SVS-15-08  
9/15/2008**TO: ALL ISUZU DISTRIBUTOR & DEALER SERVICE & PARTS PERSONNEL****SUBJECT: RADIATOR MOUNTING KIT UPDATE FOR TEREX T25 GENERATOR****MODELS AFFECTED**

4LE1PV-02 508 in Terex T25 mobile generator set.

**Old Guard Type (support rib on inside)****New Guard Type (support rib on outside)**

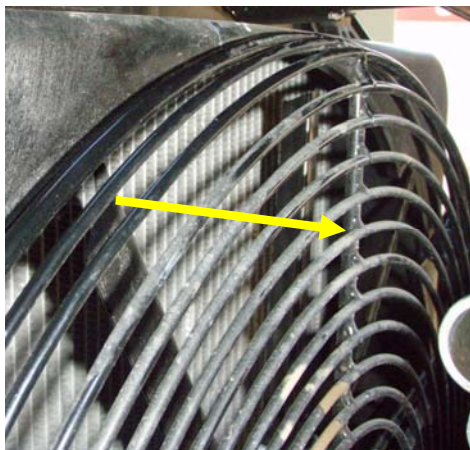
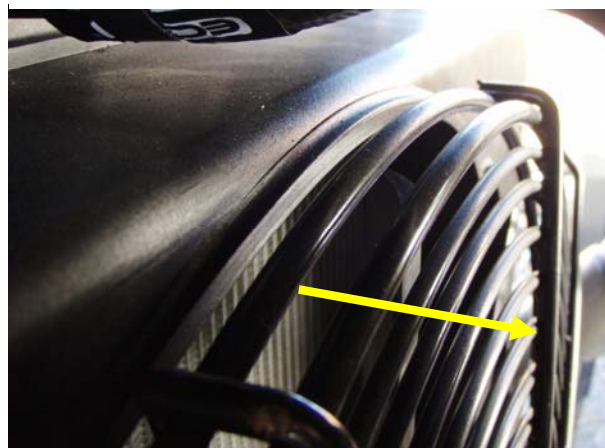
There has been an update to the radiator mounting kit for the Terex T25 mobile generator set with Isuzu 4LE1PV-02 508 power unit. There is potential for the radiator assembly to sag due to vibration; this may allow for less than 1/2" clearance between the cooling fan blade tip and fan guard/radiator assembly. If fan guard contact is made, fan breakage may occur which could lead to radiator damage and/or engine overheat.

Units that have previously been updated will have a new fan guard and do not require action. To determine if the unit has the new fan guard and update kit, please review the pictures below.

**Important:** After the update kit is installed, check for 1/2" clearance from fan tip to fan shroud, fan guard, or any object that could contact the fan, completely around the fan.
